City of Phoenix
OFFICE OF THE CITY COUNCIL

TO: PHX-MODERNIZATION-comment@faa.gov
SUBJECT: Opposition to Phoenix Area FAA Modernization Project

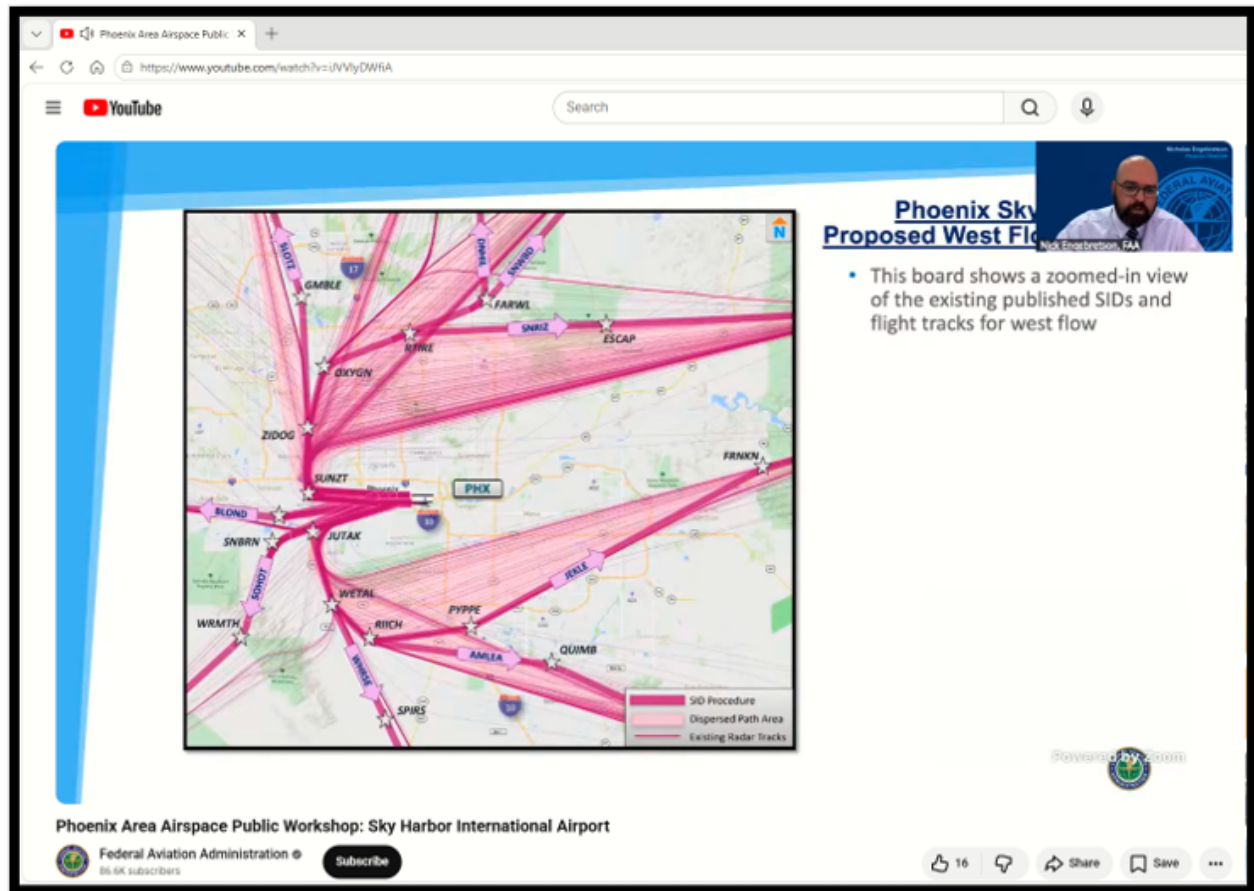
The FAA's proposed Draft Environmental Assessment (DEA) should have clearly communicated in both narrative and mapping that the 43rd Avenue Gate, at the very minimum as an olive branch in helping the community move forward, would not be modified as part of the project —the FAA chose not to do that. The FAA's choice to exclude any confirmation of the agreed upon noise abatement procedure is both outrageously out of touch, and frankly, it is insulting to our entire City. The FAA must rectify this problem above anything else as its exclusion from the DEA guaranteed the proposed action would be "highly controversial".

Throughout the Public Workshops, the FAA, in contrast to the DEA, made it quite clear multiple times that it has no intention of modifying the 43rd Avenue Gate for air carrier west flow departures (SIDs). For example, during the Sky Harbor focused Workshop on May 13, 2026, at minute 1:03:54 the FAA stated (and showed this exhibit):

"Okay, the next one. "Some procedures, including procedures going over historic communities in downtown Phoenix, list that the procedure is for turboprops and turbojets. Does that mean commercial jet aircraft will be allowed to fly the procedures over these historic neighborhoods?" "I'm gonna turn it over to you, Nick, 'cause I know you know the answer to that question. - Okay. I'd like to use another slide here. Let me figure out which one it is. It's a West Flow Sky Harbor departures, say P8 I think, or P9. Either one of those. So I kind of referenced the turboprop and turbojet difference earlier in the Group B conversation. But the westbound departures off of Sky Harbor will fly relatively the same pattern or same departures for turbojets straight out to 43rd Avenue or just past 43rd Avenue. And then they turn north and fly north as they continue to climb and get higher, which again reduces noise. There will be those turns depending on traffic and safety, whatever other aircraft are out there in the area. So to specifically answer the question, the 43rd Avenue and Tempe 4 DME will still be used. So there aren't many changes for the

turbojet departures off of Sky Harbor. The turboprops will fly that other SID that I showed in those boards earlier. - Yeah. And again, I think just to reiterate, right, commercial jet aircraft, they're gonna follow these procedures that we're showing on the screen right. Correct. - Yeah. So hopefully that answers that question.”

1. The FAA's public workshop comments and public display boards posted to the project website clearly indicate FAA's intent to continue to adhere the 43rd Avenue Gate noise abatement procedure; to ensure this intent is part of the public record the FAA must update the Draft EA and include in the Final EA maps showing the abatement procedure and narrative explaining how the 43rd Ave Gate was established and its importance going forward.

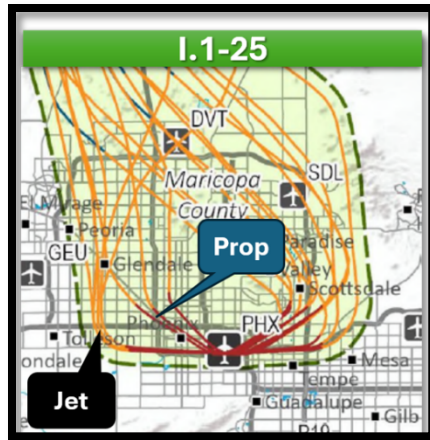
- None of the proposed route mapping (Appendix I of the DEA) delineates between aircraft groups; specifically, some proposed procedure maps combine aircraft groups (ie, Jets and Turboprops), which unnecessarily muddles the perception of 43rd Ave Gate adherence going forward as proposed Turboprop departure routing from PHX is not required to comply with the Gate yet the linework for these routes is identical to the linework for west flow Jets departing PHX which must comply with the Gate. Examples of this problem from Appendix I are shown below, note the problem also applies to proposed procedure maps for certain arrival routes impacting the Historic Districts.

- The FAA’s proposed procedures for west flow Turboprop departures from PHX shift the general routing to the east (from Grand Ave, east of over neighborhoods) and concentrates those operations relative to the current VFR diffusion. The DEA does not provide any explanation as to how or why this modification meets the stated purpose and need, nor does the DEA provide any alternatives for this action or attempt to explain what environmental impacts are specific to this action.

2. The FAA should delay implementation of the project so that the DEA can be modified to include either separate procedure maps (Appendices H and I) for different aircraft groups (Jets vs. Turboprops) or maps that differentiate between groups through the use of linework variation (eg, dash vs. solid lines). These revised map sets need to be reviewed with the community for their input before the Final EA is published.

3. The FAA should forgo changing Turboprop west flow departure procedures from PHX and continue to use vectoring in the initial departure segments to ensure the general tendency of these operations with respect to lateral location and altitude do not change. If the FAA is unwilling to forgo new IFR procedures for west flow Turboprop departures from PHX, then FAA should delay implementation of the project and develop alternative procedures for the purpose of routing rotation (to avoid concentration impacts), including an alternative more consistent with the existing "Average Track" of these operations. Finally, FAA must delay implementation so the alternative rotation procedures can be developed, modeled for noise impacts and reviewed with the Community for their input before the FEA is published.
